A d d e n d u m

Iowa Department of Transportation
Office of Contracts

B.O.	Proposal ID	Proposal Work Type	County	Project Number	Addendum
358	79-0634-050	LIGHTING	Poweshiek	NHSN-063-4(50)--2R-79	16JUN358.A01

HIGHWAY LIGHTING LAYOUT
 I-80 AND US 63 INTERCHANGE
 REVISED: 11-JUN-2015

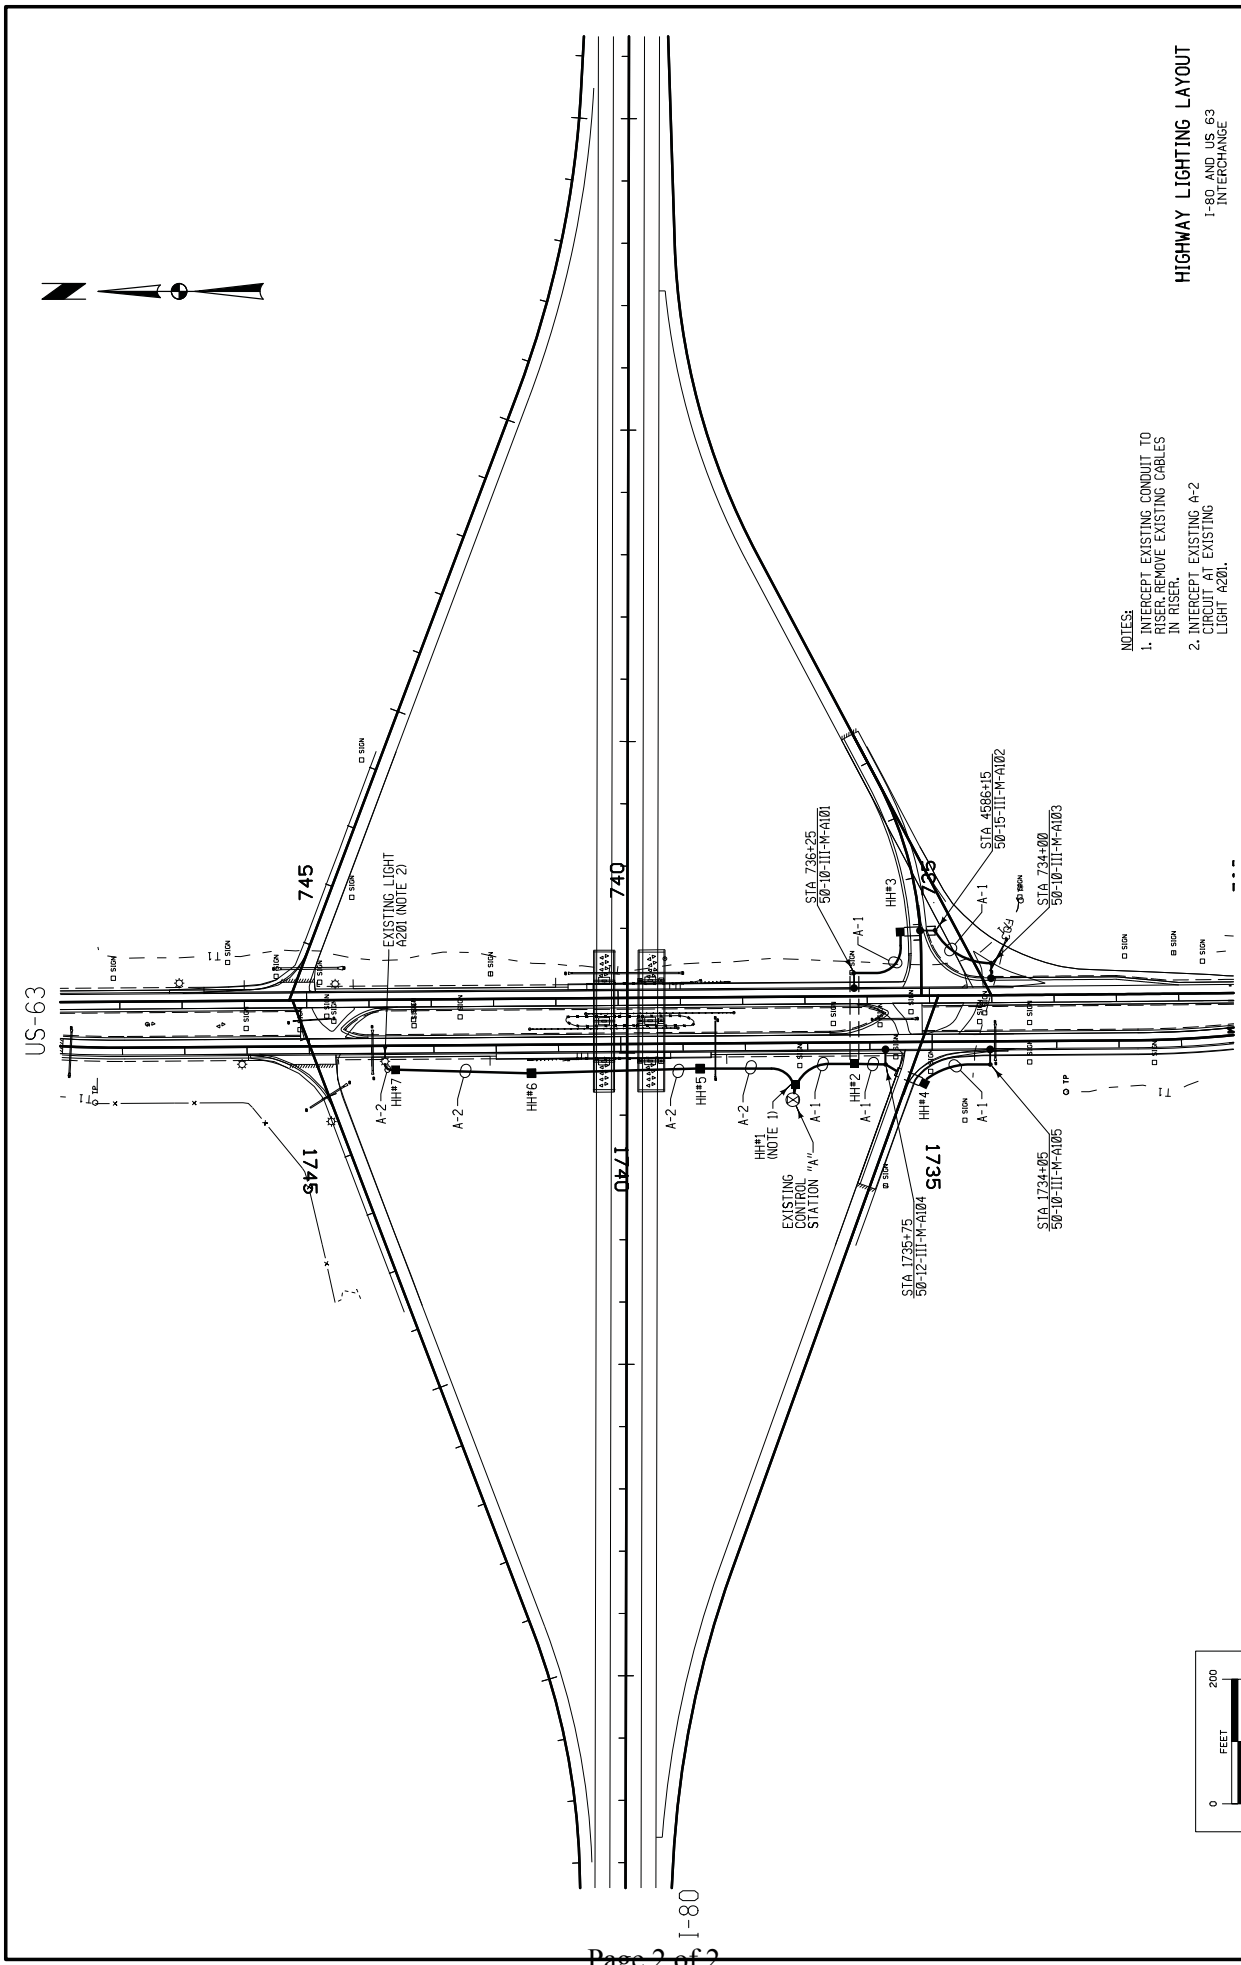
Replace plan Sheet: P.1 with the attached Plan Sheets:

NOTES:
 1. INTERCEPT EXISTING CONDUIT TO RISER, REMOVE EXISTING CABLES IN RISER.
 2. INTERCEPT EXISTING A-2 CIRCUIT AT EXISTING LIGHT A201.
